**ADDENDUM #2
TO SPEC. 05-165**

**STORM SEWER PROJECT 701683R
Washington from 16th to 17th St. from A to Garfield**

ADDENDUM NO. 2

**STORM SEWER PROJECT 701683R
17TH & WASHINGTON
SPEC. NO. 05-165**

STORM SEWER PROJECT 701683P
17TH ST. AND WASHINGTON ST.
LINCOLN, NEBRASKA
SUMMARY OF QUANTITIES

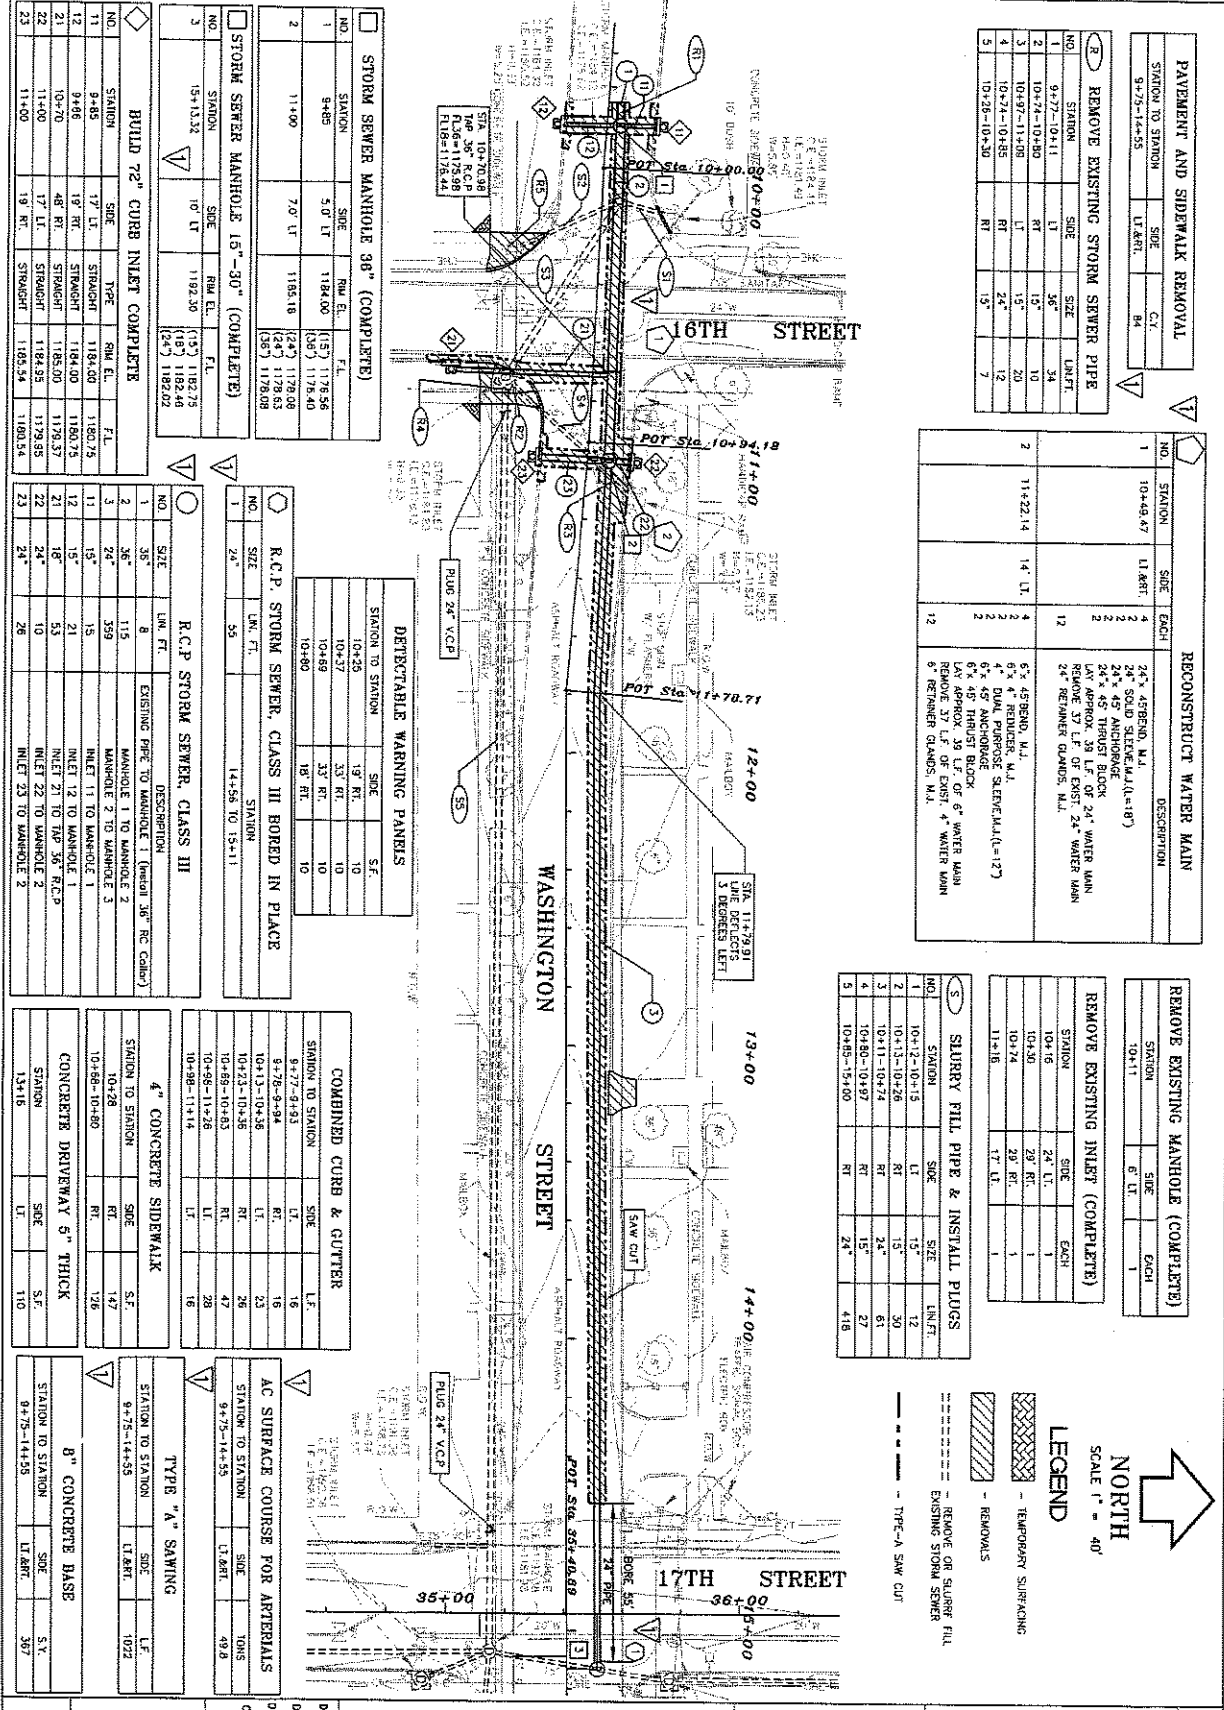
<u>Item No.</u>	<u>Description</u>	<u>Unit</u>	<u>Old Quantity</u>	<u>New Quantity</u>
20.0100	36" R.C. Pipe Storm Sewer, Bored-In-Place	L.F.	50	0
21.0090	24" R.C.P. Storm Sewer, Class III	L.F.	532	406
01.0100	Pavement and Sidewalk Removal	C.Y.	203	214
01.0105	Concrete Base, 8" Thick	S.Y.	904	937
01.0140	Asph. Conc. Surface Course For Arterial	Ton	122	127
01.0210	Type 'A' Sawing	L.F.	2748	2798
23.0008	6" Water Main	L.F.	153	39
23.0530	6" Retainer Gland, M.J.	EA.	48	12
23.0546	6" x 45 Deg. Elbow, M.J.	EA.	16	4
23.0625	6" x 4" Reducer, M.J.	EA.	1	2
23.0644	24" Solid Sleeve, M.J. (L=18")	EA.	8	2
23.0650	6" Solid Sleeve, M.J. (L=18")	EA.	8	0
23.0665	Conc. For Thrust Blocks & Anchorages	C.Y.	9	22.44
23.0670	Reinf. Steel for Thrust Blocks & Anchorages	Lbs.	272	831.80
23.0955	Remove 4" Water Main	L.F.	145	37

Please remove Sheets 2, 5, 6, 9, 10 and 11 of the plan set and replace with the revised Sheets 2, 5, 6, 9, 10 and 11.

STORM SEWER PROJECT 701683P
17TH ST. AND WASHINGTON ST.
LINCOLN, NEBRASKA
PLAN LAYOUT, REMOVALS

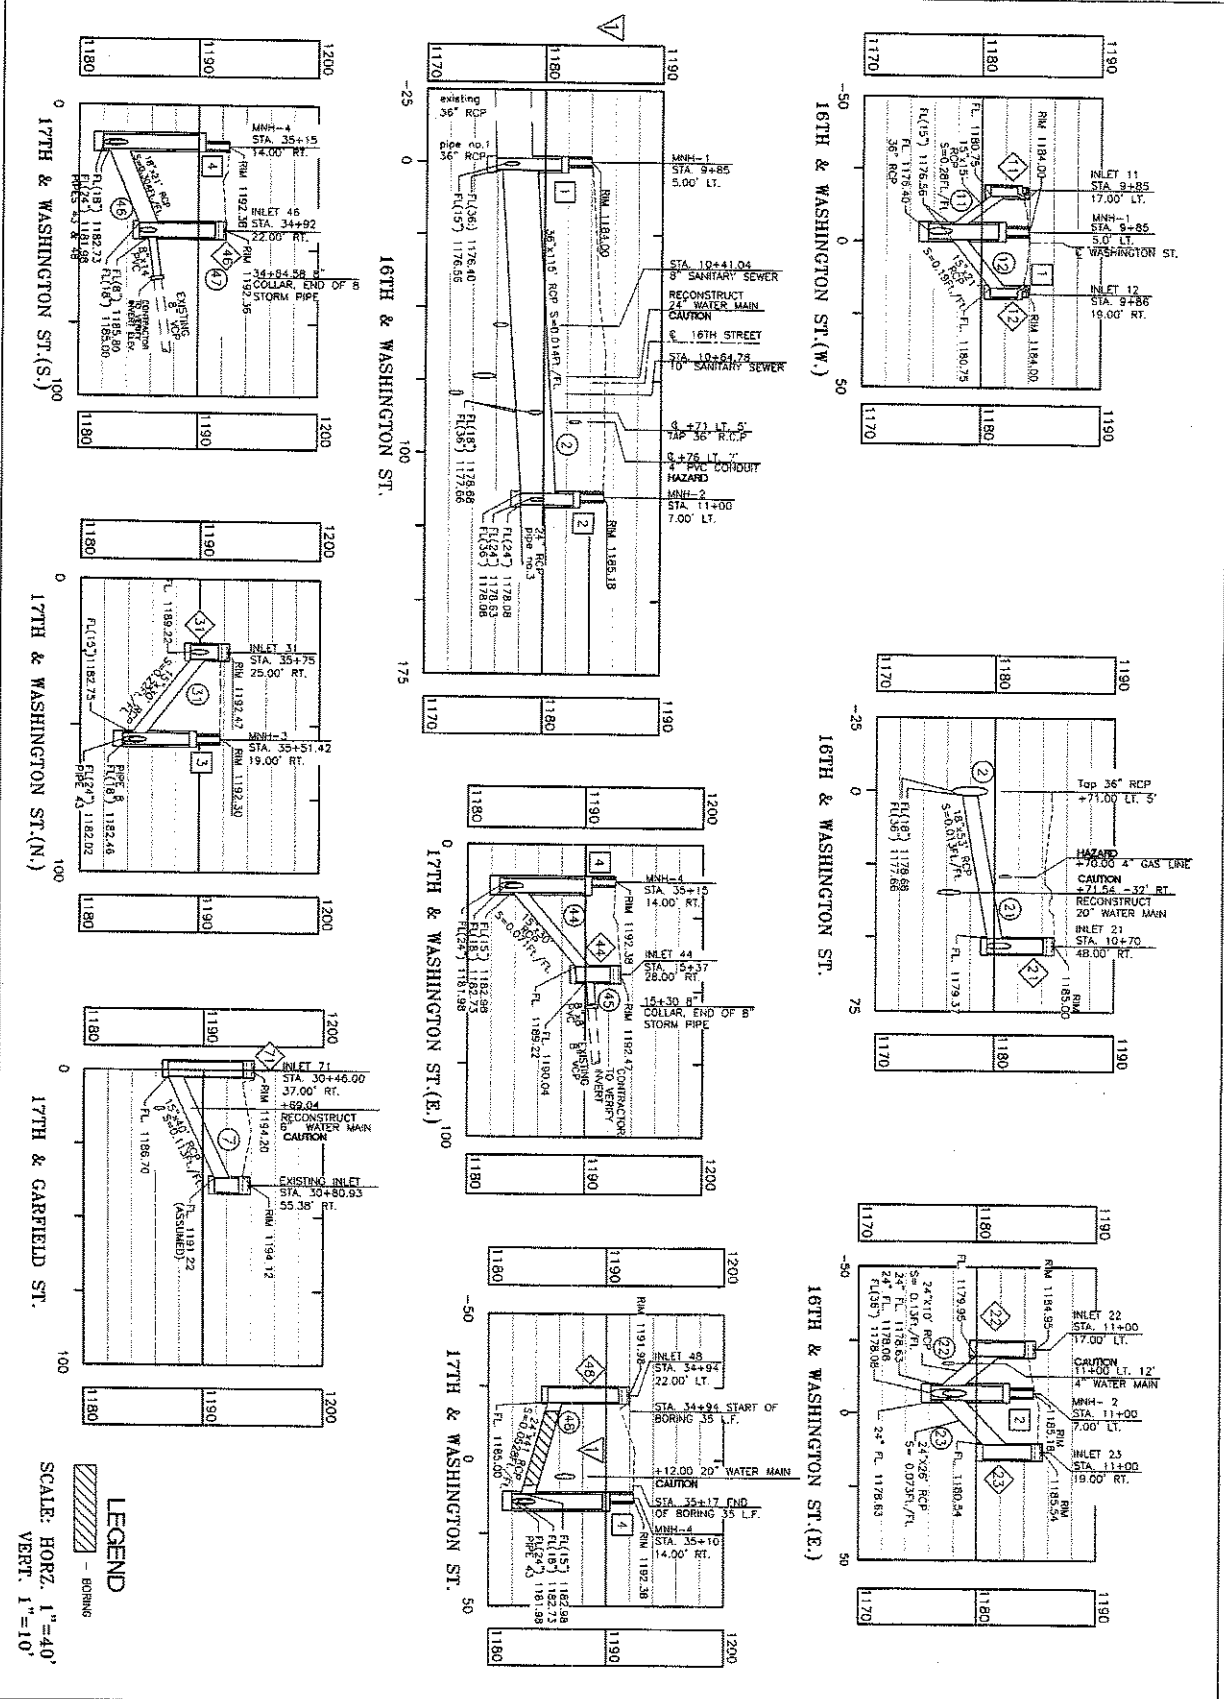
2. Please make the following changes to the "Special Construction Requirements" section of the Special Provisions. These changes were made due to the alteration in construction of the 36" Storm Sewer on Washington under 16th Street from boring to open-cut construction.

REVISIONS			
NO.	DESCRIPTION	DATE	BY
1	QUANTITIES	7/1/05	JMS

STORM SEWER PROJECT 701683R
17TH ST. AND WASHINGTON ST.
LINCOLN, NEBRASKA
PIPE AND INLET PROFILES

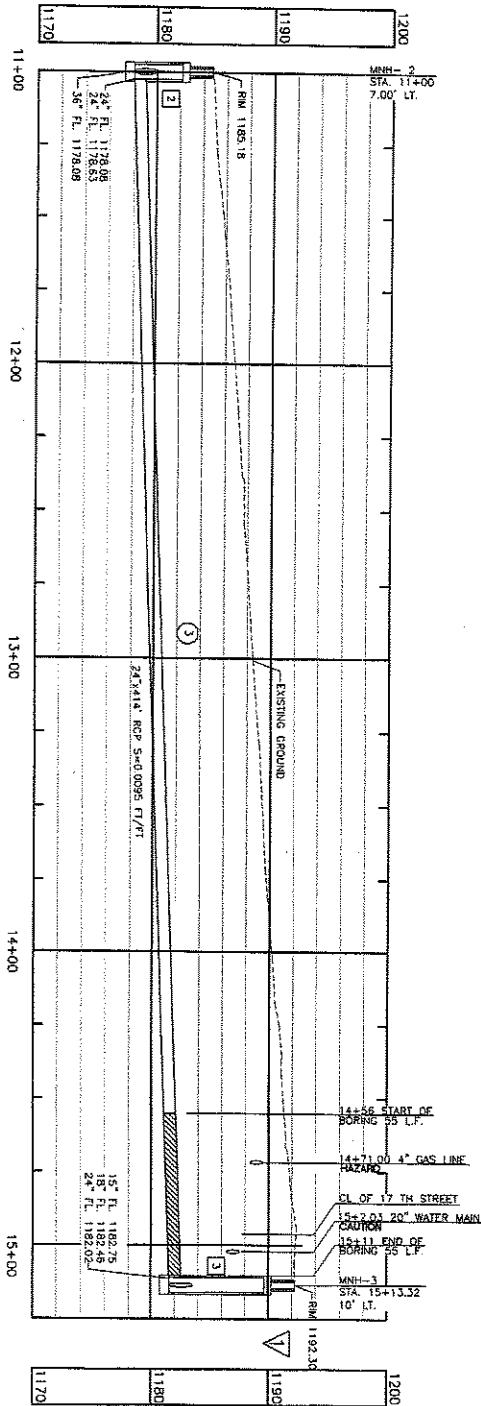
REVISIONS			
NO.	DESCRIPTION	DATE	BY
1	PROFILE CHANGES	7/1/05	JMS
